Historic Architectural Review Commission Staff Report for Item 9

Application Number: C2025-0078

Address: 417 Simonton Street

Demolition of existing dwelling unit at rear.

Existing Site Plan.

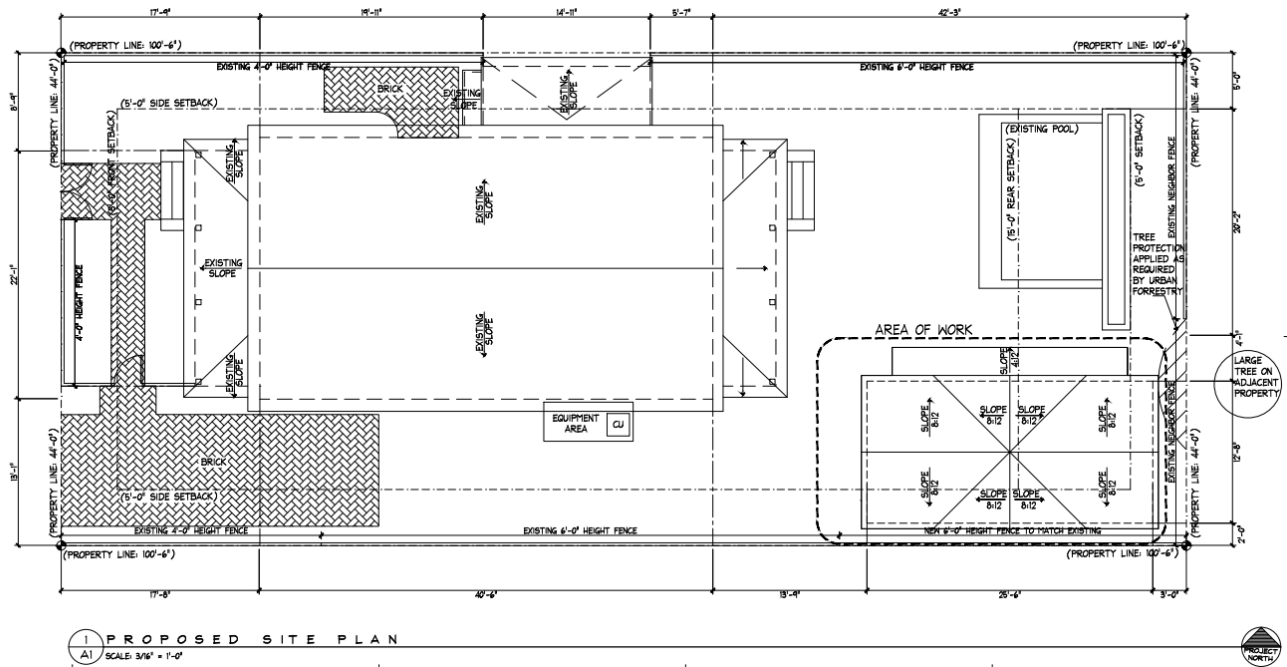
The plans also include the demolition of the existing one-story dwelling unit located at the rear of the property.

Proposed Site Plan.

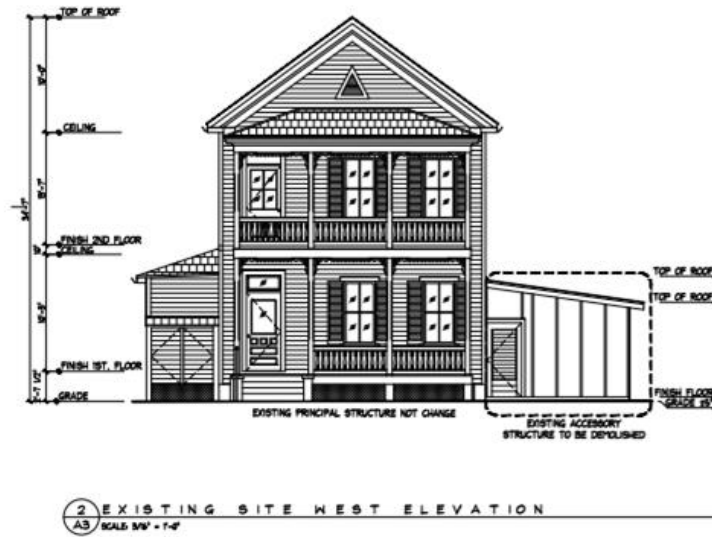
A Certificate of Appropriateness is currently under review for a new one-story dwelling unit in the rear of the property. The new dwelling unit will feature wood windows, siding to match the main structure, and 5 v-crimp roofing. The north elevation, facing the pool will feature three aluminum French doors with a canopy. The structure will also include a few triangular windows within the gable ends. The total height will be 18 feet 6 inches from grade.
